SERVICE DIRECTIVE BULLETIN NO. T-032

1. SUBJECT: Tail Rotor Cable Clearance

2. MODEL: TH-28, 480, and 480B

**Figure 1. Pulley Assembly (Left Side Shown)**

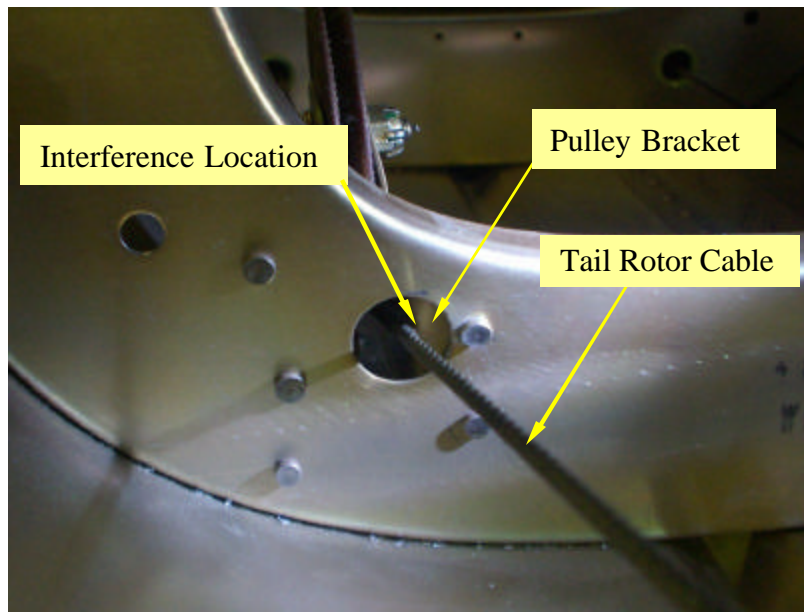
Enstrom received a field report of a tail rotor control cable rubbing on a pulley bracket in the tailcone. The cable could wear and lose strength over time. A combination of tolerance stack-up and bracket installation technique are the causes for the interference of the cable with the pulley bracket.

- A. Open the left and right side closure panels behind the aft horizontal stabilizers.
- B. Inspect the left and right tail rotor cables routing through the bulkhead holes. See Figure 1.
- C. If the left or right tail rotor cables have adequate clearance (minimum 0.030") with the pulley bracket, no action is required.

- D. If either the left or right tail rotor cable is rubbing against the pulley bracket or the pulley bracket shows wear from the cable, proceed to step 5.2 to increase the clearance between the cable and the pulley bracket.

Figure 2. Pulley Assembly Repair Installation

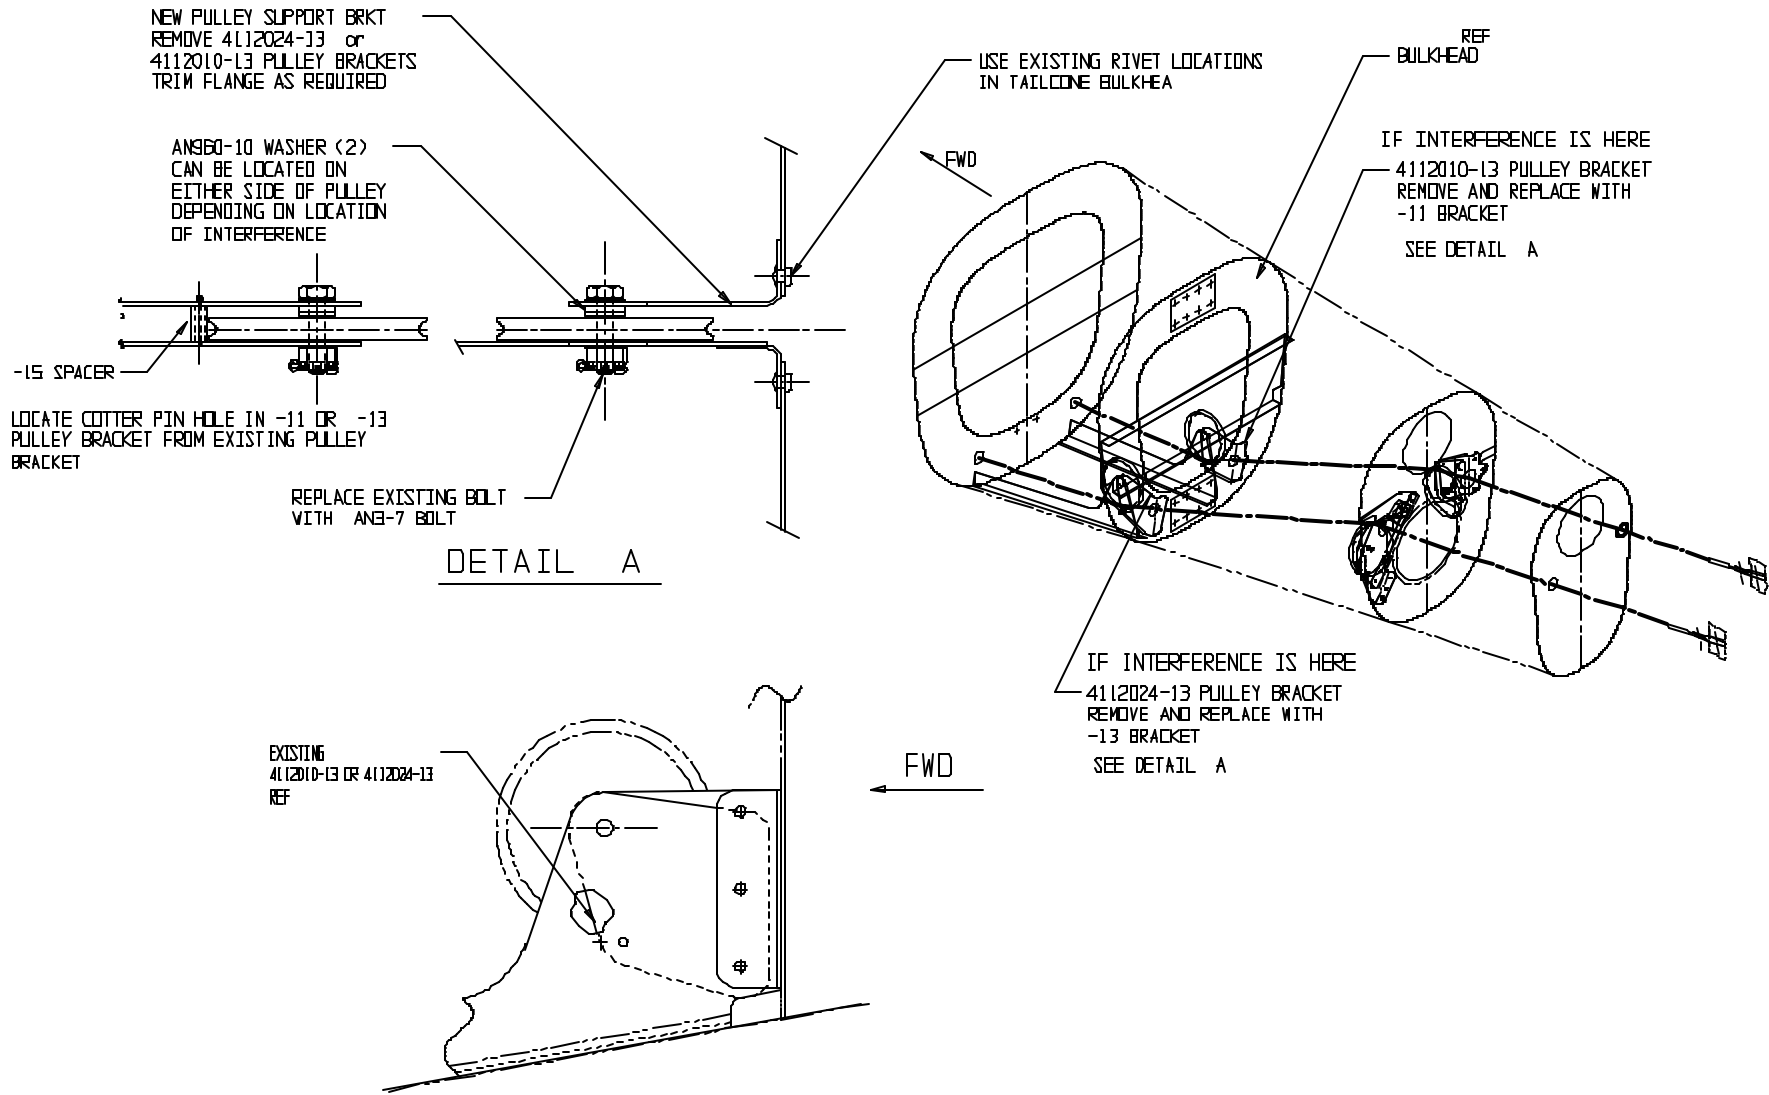
- A. Disconnect the tail rotor cables from the gear box.
- B. Remove the interfering pulley bracket, existing spacer, and bolt. Reference Figure 2.
- C. If the left side pulley bracket is removed, install new pulley bracket P/N 4230033-13. If the right side pulley bracket is removed, install new pulley bracket P/N 4230033-11. Trim flange as necessary for fit. Use existing rivet locations in the bulkhead.
- D. Two (2) AN960-10 washers can be located on either side of pulley depending on location of interference. Use AN3-7 bolt to install pulley to the bracket assembly.
- E. Locate and drill hole for spacer through the pulley bracket assembly. Install spacer P/N 4230033-15.
- F. Reconnect the tail rotor cables.
- G. Check tension/rigging per the maintenance manual.
